Access Compliance Report

Public Rights-of-Way

(Curb Ramps)

Intersection ID: 17743	Main Street: LORENE_AV	Cross Street: SELWYN_AV	Location: SE
ADA ID: 315CA53E336E	Ramp Type: Directional1	Initial Pass/Fail: Fail	Overall Compliance: No
		Severity Score: 35

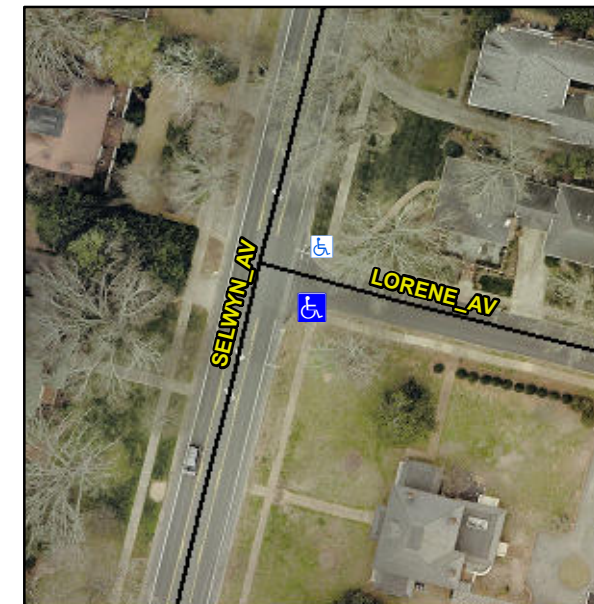
NO CURB LINE

R304.5.1, R304.2.2, R304.5.3

Remove & Replace Entire Ramp.
